CITY OF ALBUQUERQUE

**RE: ABCWUA Customer Service and Operations Facility - 6000 Alexander Blvd NE
G&D Plan and Drainage Report Engineer's Stamp Date 4/15/2019
Hydrology File: F16D014C**

The referenced submittal received on 4/22/2019 cannot be approved for Building Permit or Grading Permit. The following comments must be addressed prior to approvals.

GRADING AND DRAINAGE REPORT

GRADING AND DRAINAGE PLAN

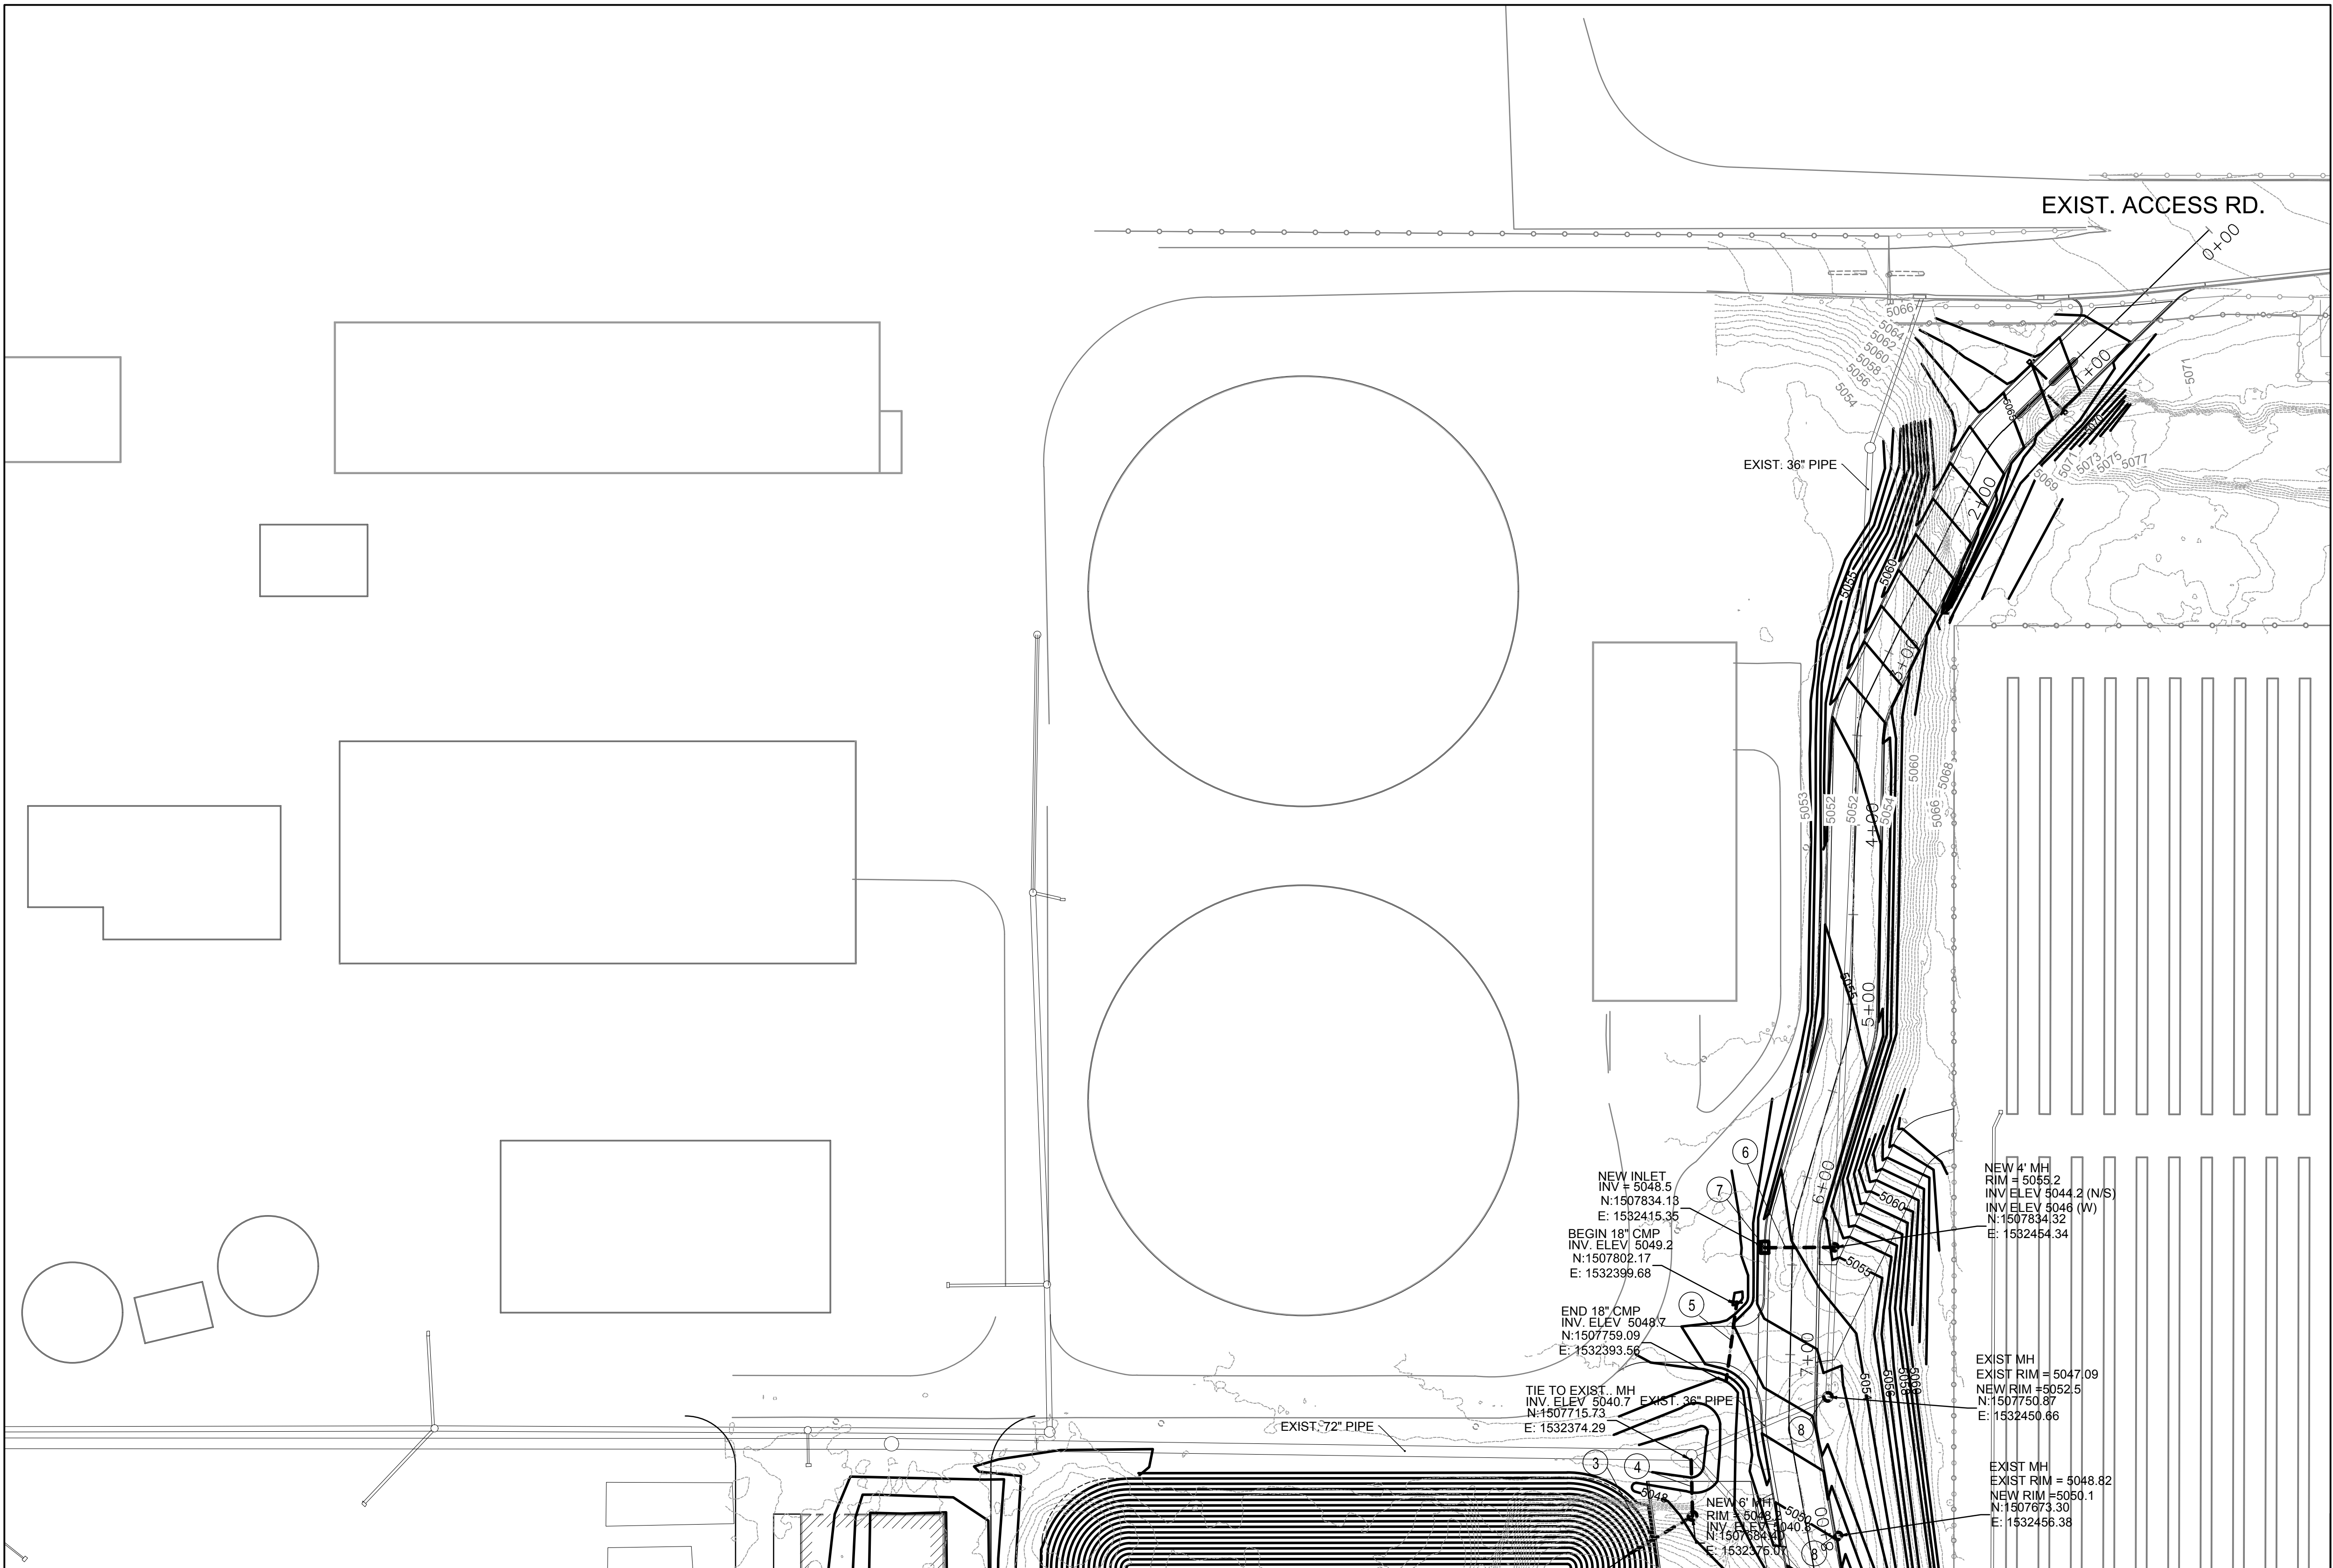
- 3) The Vicinity map and Legal description should be included on the G&D Plan per DPM Chap 22.7 Grading and Drainage Plan Checklist. The legal description is "Tract A Plat of Tract A City of Albuquerque Water Treatment Facility containing 162.5256 acres".

- 4) The entire 163 acre site must be brought up to current standards. Please add an overall sheet showing all of the ponds on this site and grading details of all the ponds existing and proposed for approval prior to building permit. The focus of the report needs to be changed from "increased ponding for the increased impervious" to "limited discharge and or retention for the entire 163 acre site".

- 7) Where does the solar array basin drain to? Add a detail of the new storm drain junction structure at the north east corner of the new north pond.

- 8) Provide 100 year hydraulic capacity calculations and details for each of the rundowns and curb openings. Identify the curb height in the parking lots.
